Regional Development Assessment Panel Related Information

Meeting Date and Time: Wednesday, 22 January 2025; 9:30am
Meeting Number: RDAP/34

3.1 Lots 71, 72, ,73, 74 (No. 21 & 23) Pritchard Street, Manjimup – Motel and Restaurant – DAP/24/02791

PRESENTATION TO REGIONAL DAP MEETING 22 JANUARY 2025 (RDAP/34) AGENDA ITEM PART B ITEM 3.1 – MOTEL & RESTAURANT DEVELOPMENT 21 & 23 PEITCHARD STREET, MANJIMUP

Applicants Calculation of Motel "Service Area"

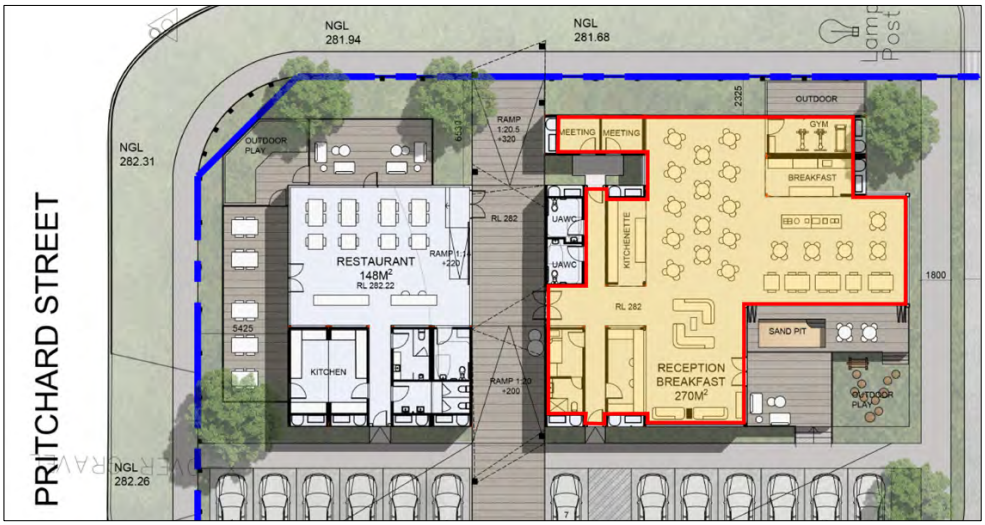
Applicant's Calculation of Service Area

"Service Area" should be limited to those facilities with potential to generate demand for car parking from staff and non-guests, including the reception, administration and caretaker. As indicated on the drawings, these "Service Areas" have an area of 270m^2, as shown below.

With a floor area of 270m^2, the "Service Areas" as calculated by the Applicant generate a parking requirement of 10.8 bays, which is more than adequate to meet parking demand from staff and other visitors / personnel who may attend the site.
